ADDENDUM NO. 1

Reconstruct Runway 18/36, Lighting, PAPI's, REIL's & Wind Cone
Gould Peterson Municipal Airport
Tarkio, Missouri

MoDOT# 18-001A-1A

Olsson Project No. 019-1607

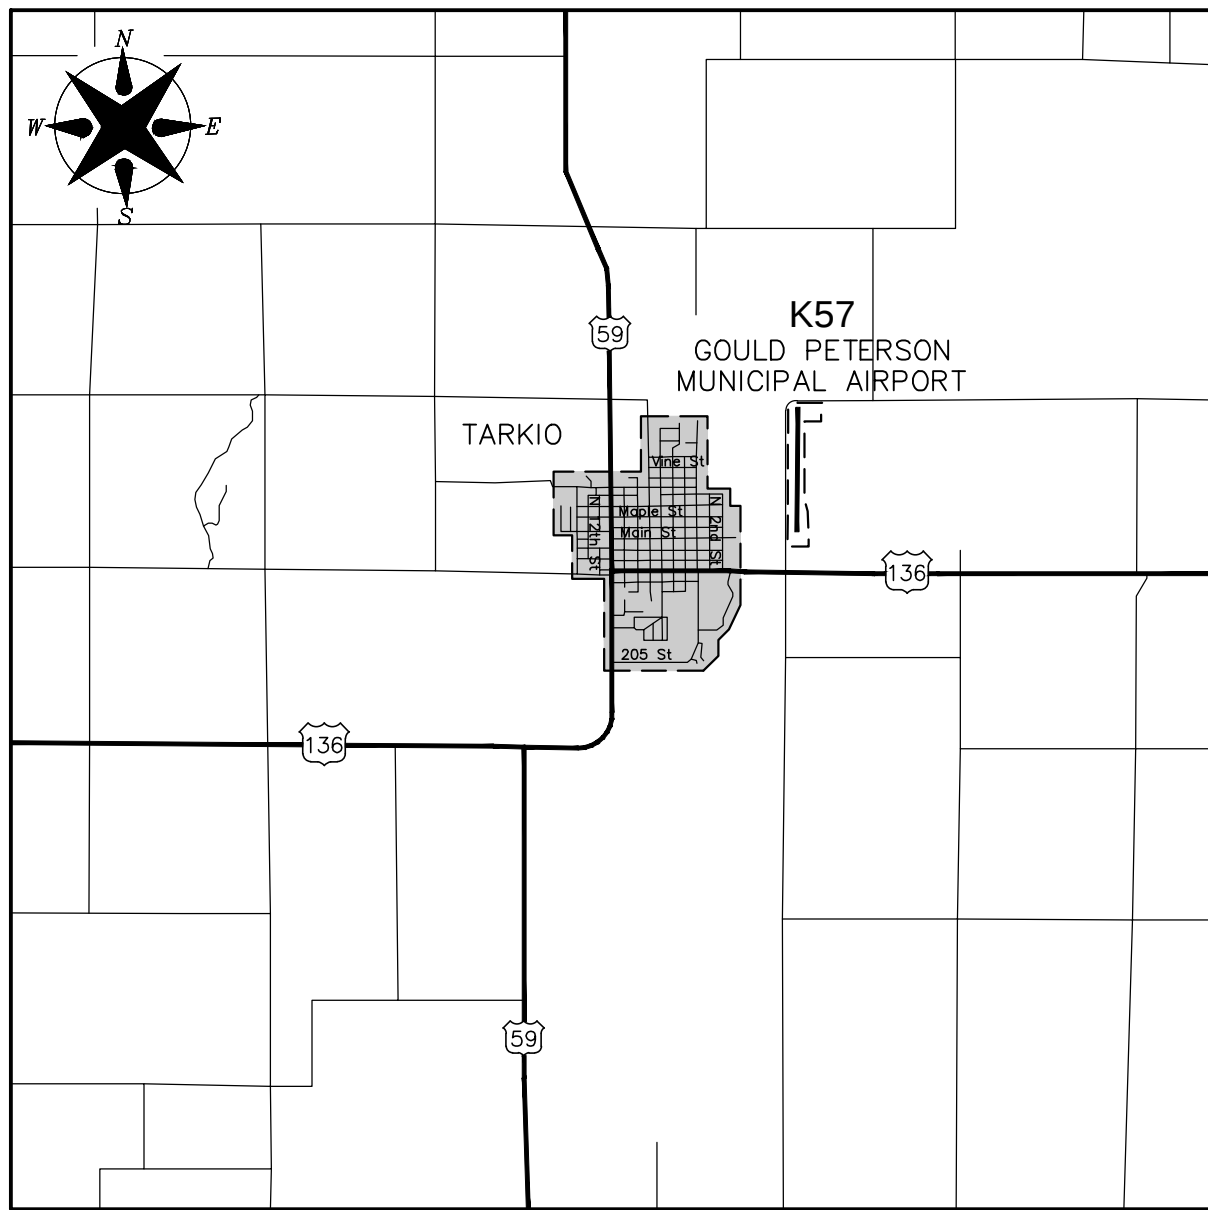
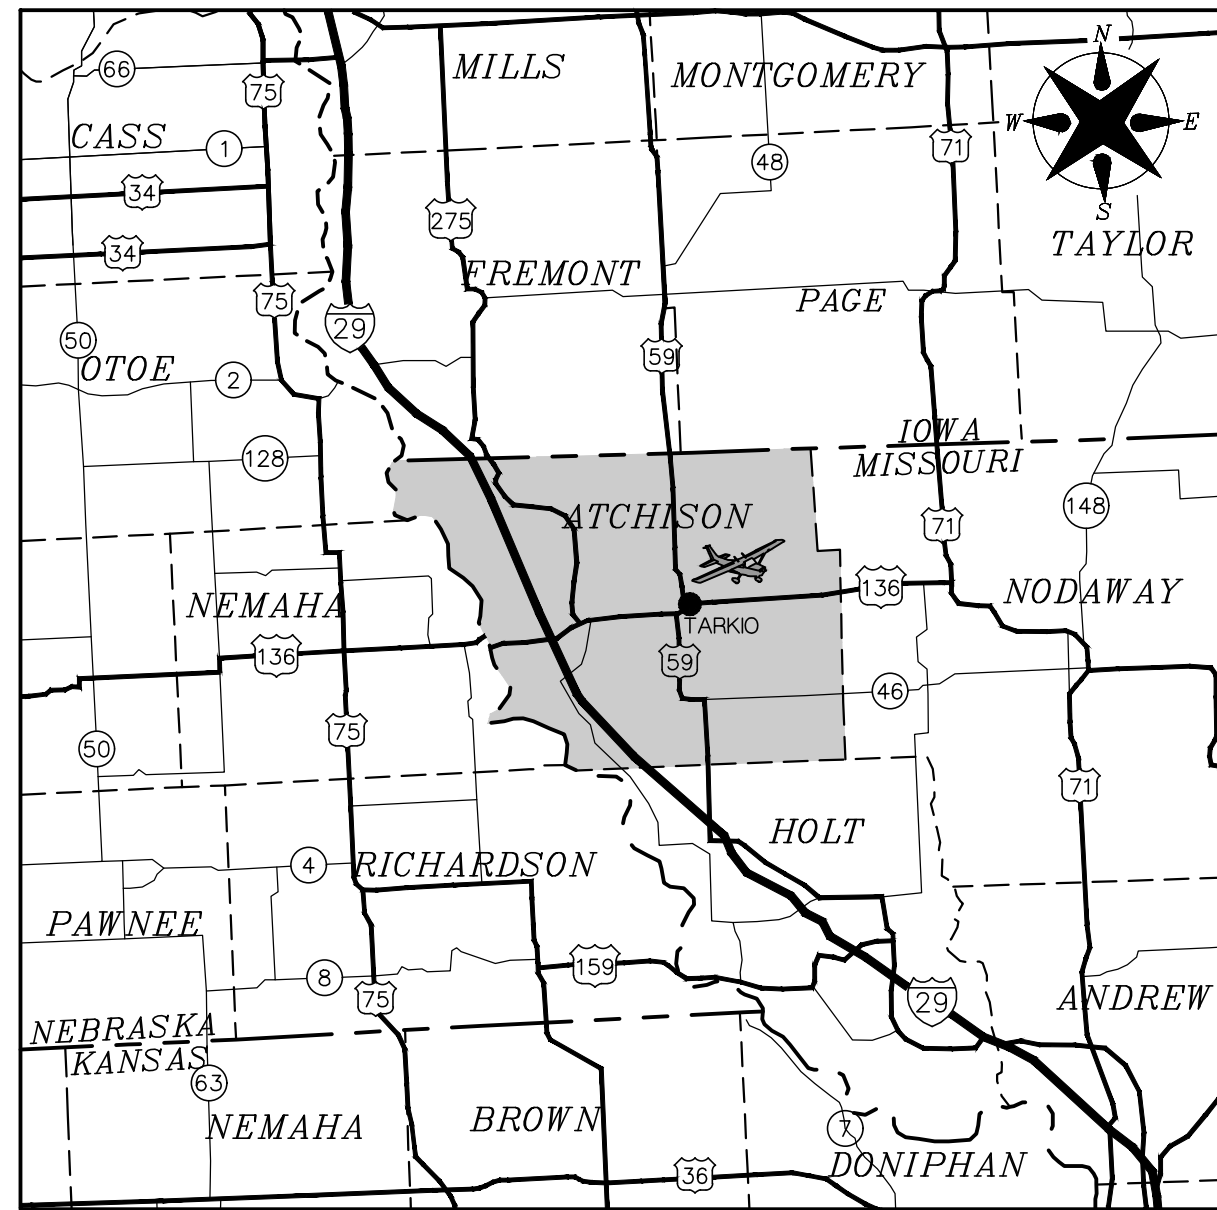
1. Cover Sheet: Corrected Cross Section Sheet Index "Sheet Numbers". Delete the Cover Sheet in its entirety and replace with the attached Cover Sheet.
2. Sheets XS-1 to XS-21: Runway 18/36 Cross Sections: Cross Sections Sheets did not have an Engineer's Seal. Delete Sheets XS-1 to XS-21 in their entirety and replace with the attached Sheets XS-1 to XS-21.
